# Access Compliance Report

## Public Rights-of-Way

### (Curb Ramps)

Intersection ID: 26840	Main Street: OLD_COURSE_DR	Cross Street: REA_RD	Location: NE
ADA ID: 57EDA541F8C3	Ramp Type: PerpDiag	Initial Pass/Fail: Fail	Overall Compliance: No
Codes/Mitigation Info/Possible Solution		Field Measurements/Component Compliance

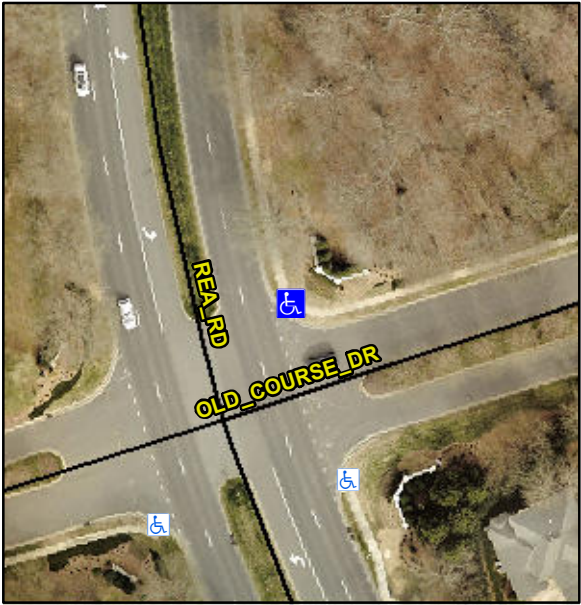
Possible Solutions:	Compliance	Description	Data	Compliance	Description	Data
	Remove & Replace Curb Ramp With Two New Directional Ramps or Equivalent.	N/A	Ramp Length (in)	96.0	No	Ramp Slope (%)	11.4
<p>Surveyor Notes:</p> <p>N/A</p> <p>PROW/ADA:</p> <p>Not Found, R304.2.2, R304.5.3</p>		Yes	Ramp Width (in)	48.0	No	Ramp XSlope (%)	2.6
		N/A	Flare Type LT	N/A	N/A	Flare Type RT	N/A
		N/A	Flare Slope LT (%)	N/A	N/A	Flare Slope RT (%)	N/A
		N/A	Flare Traversable LT?	N/A	N/A	Flare Traversable RT?	N/A
		N/A	Landing Length (in)	N/A	N/A	DWS Provided?	N/A
		N/A	Landing Width (in)	N/A	N/A	DWS Contrast?	N/A
		N/A	Landing Slope (%)	N/A	N/A	DWS Length (in)	N/A
		N/A	Landing X Slope (%)	N/A	N/A	DWS Full Width?	N/A
		N/A	Landing Curb? (Y/N)	N/A	N/A	DWS Offset (in)	N/A
		N/A	Shared Landing?	N/A			
		N/A	Gutter Ponding?	N/A	N/A	Gutter Slope (%)	N/A
		N/A	Gutter Lip Ht (in)	N/A	N/A	Gutter X Slope (%)	N/A
		N/A	Painted X Walk1?	No	N/A	Painted X Walk2?	No

X Walk 1 Direction	To SW		X Walk 2 Direction	To SE
		N/A	X Walk 1 Width (in)	N/A	N/A	X Walk 2 Width (in)	N/A
			X Walk 1 Slope (%)	13.5		X Walk 2 Slope (%)	7.6
			X Walk 1 X Slope (%)	2.8		X Walk 2 X Slope (%)	15.4
		N/A	Ramp inside XWalk1?	N/A	N/A	Ramp inside XWalk2?	N/A
			Road Slope (%)	4.3	N/A	Clear Space?	N/A
			Road X Slope (%)	12.8	N/A	Clear Space to XWalk (in)	N/A
		N/A	Any Obstructions?	N/A	N/A	Storm Grate/Utility Hazard?	N/A
			Obstruction Type			Storm Grate/Utility Type	
				N/A			N/A
					Yes	Surface Condition? (G/P)	Good
